Subject: Cedar View at Glennwood PRD; Request for Revisions; P-11-04-25-02

**To:** Entile Fund Five LLC  
**From:** Donald Washburn, Engineering Technician  
**Subject:** Cedar View at Glenwood Planned Residential Development; P-11-04-25-02  
**Date:** 12/26/2025

CEDARVIEW AT GLENNWOOD PLANNED RESIDENTIAL DEVELOPMENT  
POULSBO, WASHINGTON

C5.00

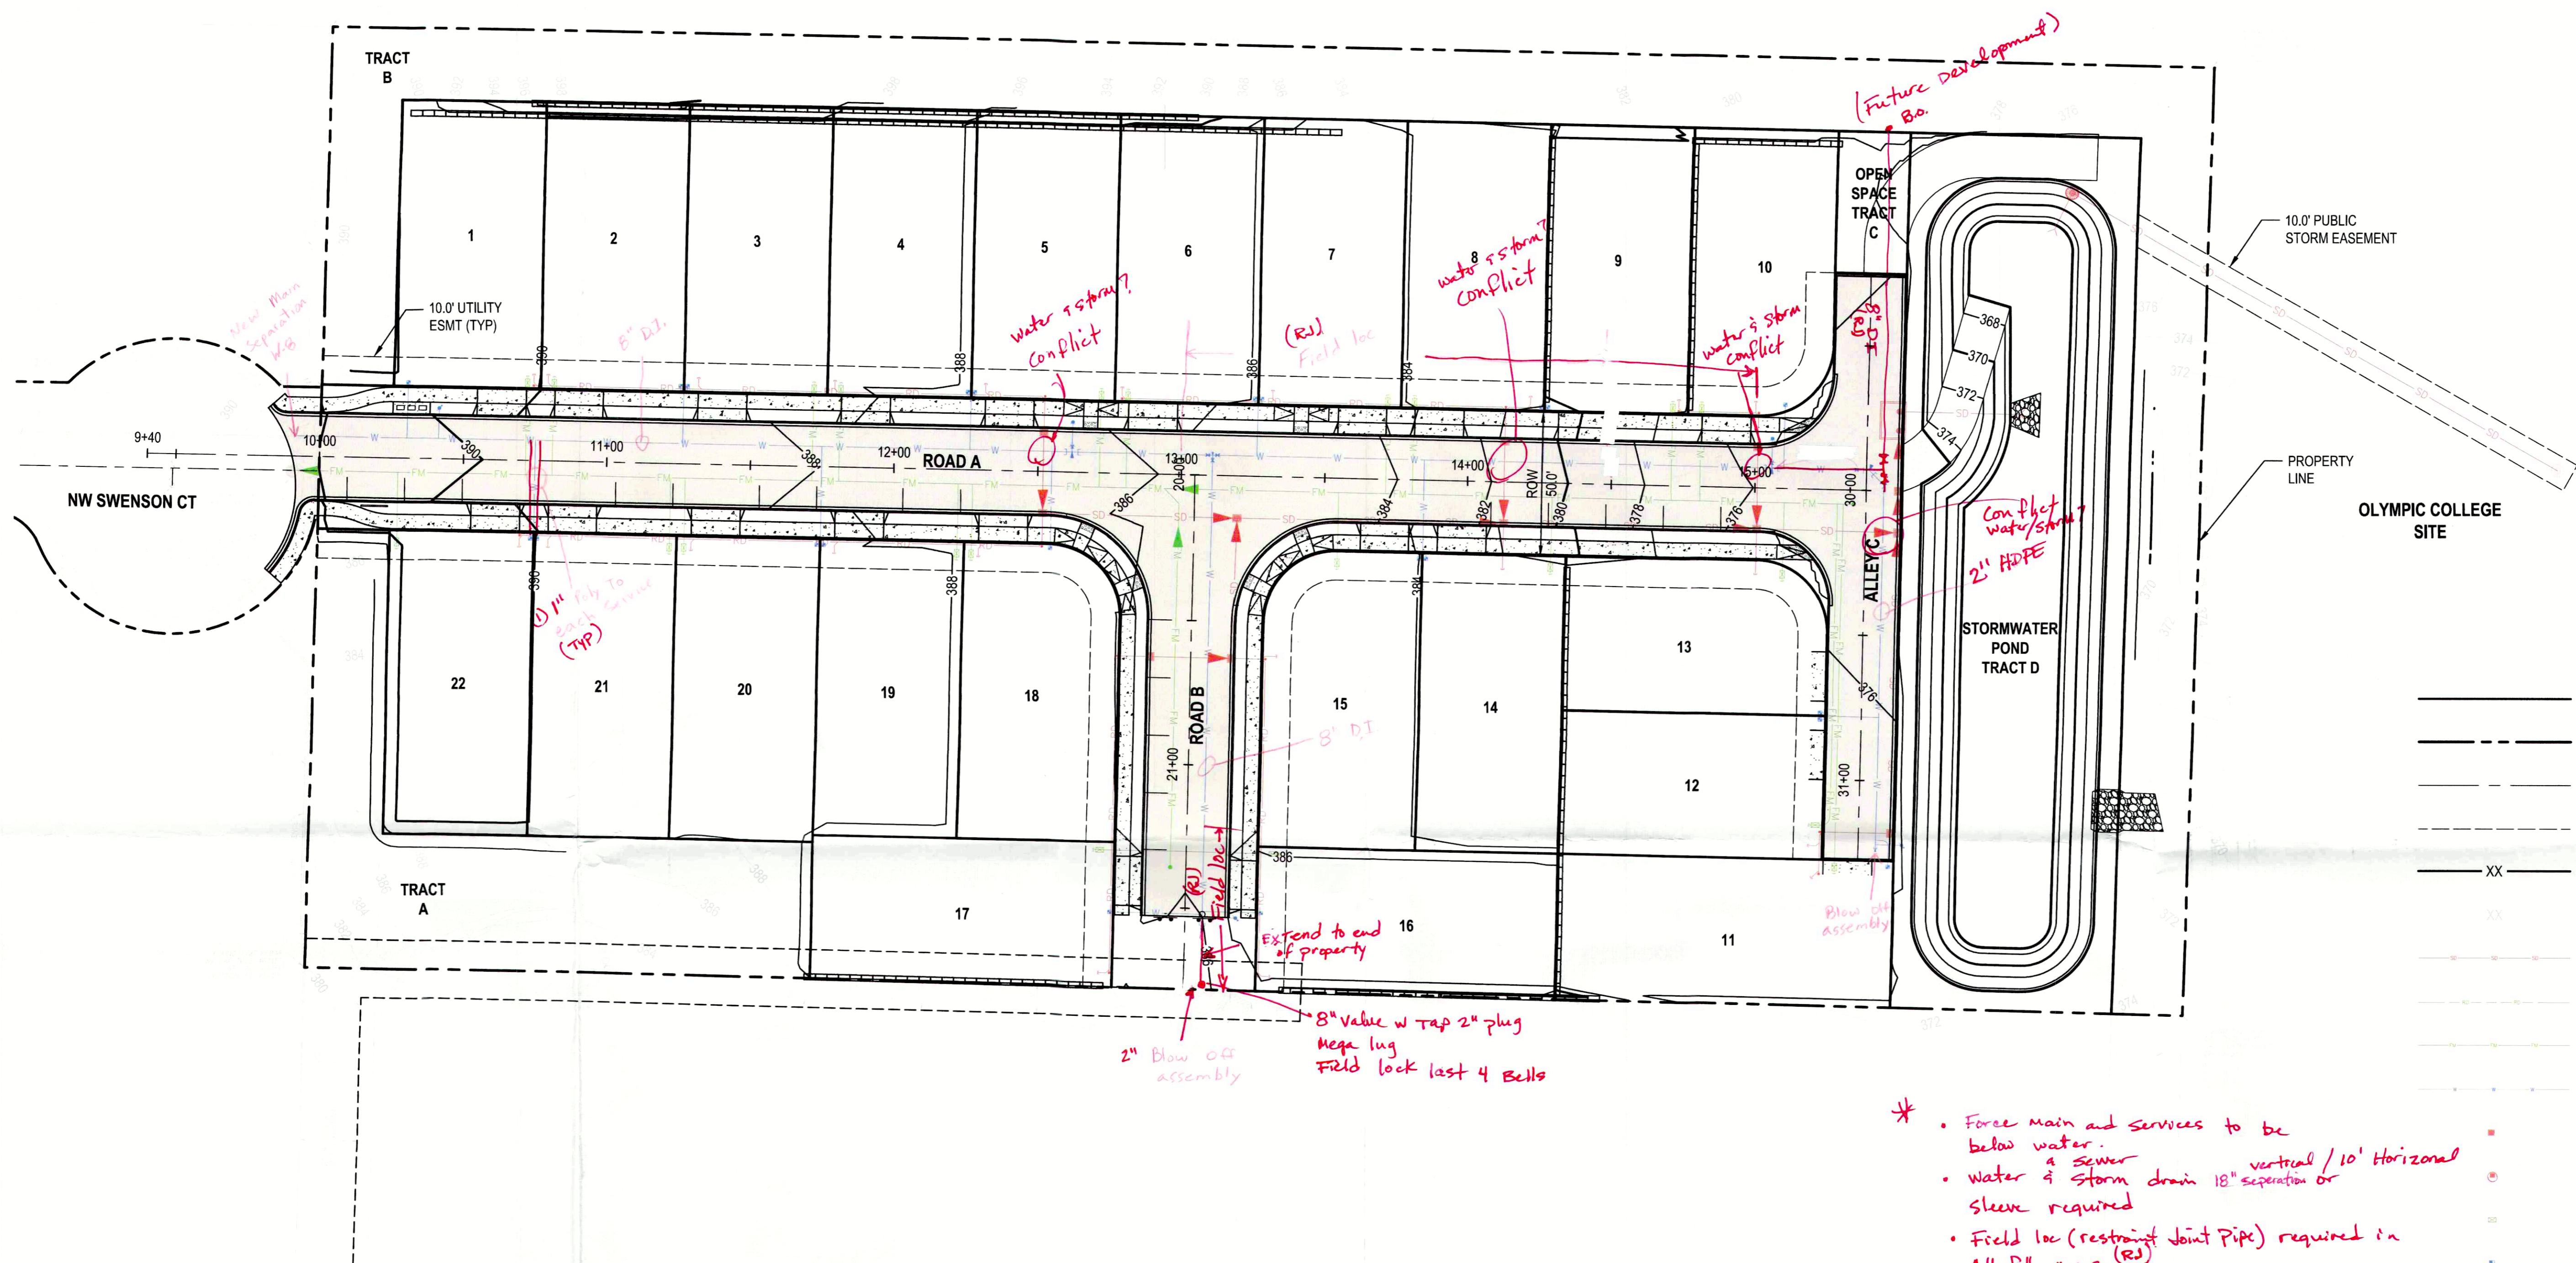
3. Sheet C5.00 – The 10' Public Storm Easement on the Olympic College Site shall be recorded prior to preliminary plat approval. The City will require proof that this easement has been recorded or a written agreement from Olympic College.

5. Sheet C5.00 – Please clarify downstream path for emergency overflow on storm pond.
6. Sheet C5.01 – Plan set contains two catch basins near Swenson CT that are not labeled or shown in side profile. Where are these connected?

8. Sheet C5.00 – Please provide more detail for sewer force main. Plan set should show location of air vacs, and pig ports.
9. Sheet C5.01 – It appears gravity sewer is achievable on lots 1-4, and lots 19-22. Gravity sewer shall be required on all lots able to connect to limit the usage of grinder pumps.
10. All force main lines within the development shall be privately owned and maintained. The force mains can NOT be located in public ROW. Plan set should clearly indicate where the pressure lines end and gravity lines begin. A cleanout will be required on all transitions from pressure to gravity lines.

13. Sheet C5.00 – Retaining walls on lots 16 and 17 likely cannot be constructed without trespass onto adjacent south lots.
14. Sheet C5.00 – It appears that the retaining walls for lots 16 and 17 are located within 20ft utility access easement. The city does not allow walls or structures to be placed within utility easements.
15. Sheet C5.02 – Road A contains a substandard K value for road sag. City streets intended for 25 mph speed shall follow the AASHTO criteria of K minimums of 12 for crest and 26 for sag.
16. Sheet C5.03 – Pavement for Road B appears to end around 25 feet away from property line. Future road extensions shall end within 6 feet of the property line. Utilities shall be stubbed to south properties.
17. Anticipate the requirement for frontage and sidewalk in Alley C for lots 11, 12, and 13.

- Force main and services to be below water.
- Water & storm drain 18" vertical / 10' horizontal separation or sleeve required.
- Field loc (restraint joint pipe) required in all fill areas. (RJ)
- Topd standards.
